IMPORTANT SAFETY RECALL

August 2011 FL607 NHTSA #11V-283 Interim Recall Notice

Subject: Western Star Airlines

Fig. 1

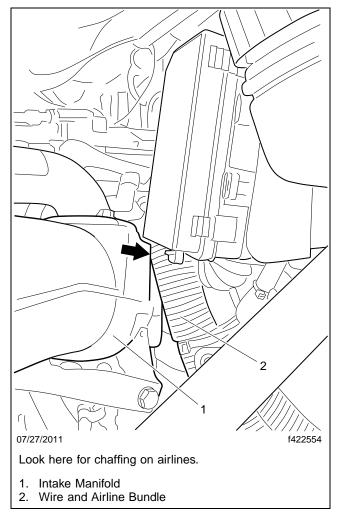
- 1. Park the vehicle on a level surface, shut down the engine, and set the parking brake. Chock the tires.
- 2. Open the hood.
- 3. Inspect the airlines and wire harnesses between the PDM and the air intake manifold in the area indicated in Fig. 1.

If there is evidence of chaffing or the lines are within 0.75 in (19 mm) of the intake manifold, take the vehicle to an authorized Daimler Trucks North America dealership for repair.

If there is no chaffing and adequate clearance (0.75 in (19 mm) or more from the intake manifold), no action is needed.
